Access Compliance Report Public Rights-of-Way (Curb Ramps)

Main Street: VANDERLIP_AVE		Cross Street: BRENAN_WAY		Location:	NW
ADA ID: RPAT211006093011	Ramp Type: Type 4 - Parallel	Initial Pass/Fail: Fail	Overall Compliance: No	Severity Score:	15
Codes/Mitigation Info/Possible Solution			Field Measurements/Component Compliance

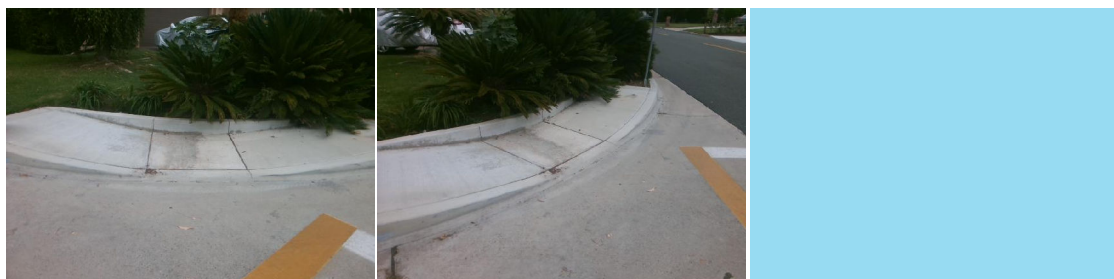
Compliance	Description	Data	Compliance	Description	Data
N/A	Ramp Length LT (in)	93	N/A	Ramp Length RT (in)	116
Yes	Ramp Width LT (in)	52	Yes	Ramp Width RT (in)	48
Yes	Ramp Run Slope LT (%)	7.6	No	Ramp Run Slope RT (%)	9.9
Yes	Ramp Cross Slope LT (%)	0.2	Yes	Ramp Cross Slope RT (%)	1.4
N/A	Landing Present	N/A	N/A	DWS Provided	N/A
N/A	Landing Length (in)	N/A	N/A	DWS Contrast	N/A
N/A	Landing Width (in)	N/A	N/A	DWS Length (in)	N/A
N/A	Landing Run Slope (%)	N/A	N/A	DWS Full Width	N/A
N/A	Landing Cross Slope (%)	N/A		DWS Offset Type	N/A
N/A	Landing Movement Obstructed?	N/A	N/A	DWS Offset Left (in)	N/A
	Landing Movement Type	N/A	N/A	DWS Offset Right (in)	N/A
N/A	Landing Shared	N/A			
N/A	Clear Space	N/A			
N/A	Clear Space To Crosswalk (in)	N/A			
N/A	Marked Crosswalk 1	Yes	N/A	Marked Crosswalk 2	N/A
	Crossing 1 Direction	S		Crossing 2 Direction	N/A
	Marked Crosswalk 1 Width (in)	120		Marked Crosswalk 2 Width (in)	N/A

Remove & Replace Entire Ramp.
